SKEP III Home Office Support Site Visit Report

Consultant	Wahib Medanat Consultant Engineer	Rep No.	23-18122021
Contractor	Dijlah Establishment Constr. Contracting	Tender No.	(11/2019/USAID/SKEP/3/S) Schools for a Knowledge Economy Project (SKEP) - Phase (3) Package (1, 2)
Site Name	Jumana Bint Abit Taleb Basic Mixed School - Jerash	Day/ Date	Sat. 18/12/2021
Duration of Project	450 Calendar Days	Total Project Budget	8,314,983.735 JD

& 03)

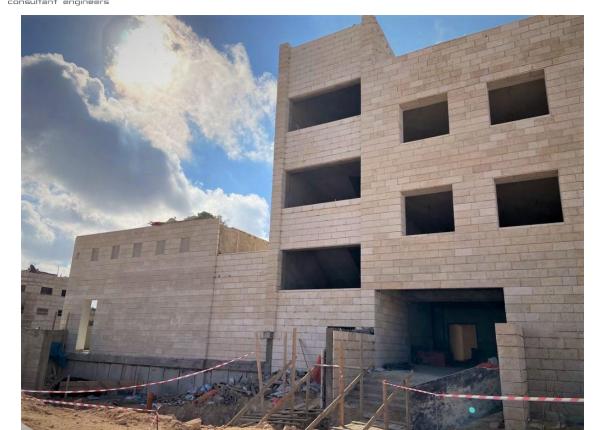
The supervision team inspected the stone facades and comments were given to the Contractor (figures: 01, 02
